CONDITIONS OF APPROVAL:

Engineering - Final Plat Checklist

6. C. Final Plat

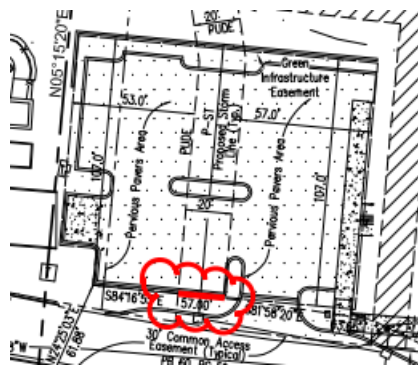
8. C. Final Plat

joe.marlo@franklintn.gov Applicant to close off the GIE polygon around the pervious paver area, as indicated below.

Site Plan - Green
Final Plat - Red

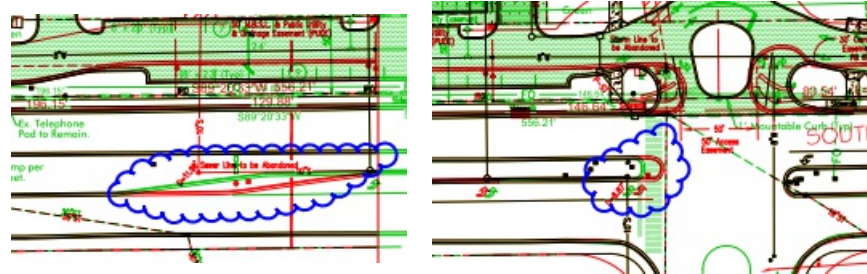
13. Riparian Buffers

joe.marlo@franklintn.gov Comment only partially addressed.

Show riparian buffers matching the associated Site Plan (#6753), including that clouded below in blue.
